## PRODUCT/PROCESS CHANGE NOTICE (PCN)

PCN #: <b>A0705-01</b>	DATE: <b>6/11/2007</b>	MEANS OF DISTINGUISHING CHANGED DEVICES:	
Product Affected: Ceramic DIP, Sidebraze and Topbraze of 28 leads or more (Refer to Att. II for affected part numbers)		<input type="checkbox"/> Product Mark	Shipment starting from 9/11/2007
Date Effective: <b>9/11/2007</b>		<input type="checkbox"/> Back Mark	
		<input type="checkbox"/> Date Code	
		<input checked="" type="checkbox"/> Other

### ATTACHMENT I - PCN #: A0705-01

Figure 1: Existing material - Silicon bump

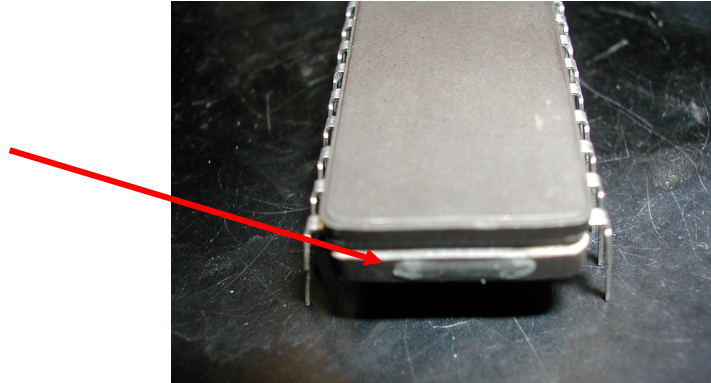
**PCN Type:** Assembly Material Change  
**Data Sheet Change:** None  
**Detail Of Change:** This notification is to advise our customers that there will be a change of material from silicon bump to bumper tape, which is applied at the package end (opposite pin 1) to prevent package crack or chip as a result of knocking between units.

Description	Existing Material	New Material
Material	Silicon bump	Bumper tape

Figure 2: New material - Bumper tape
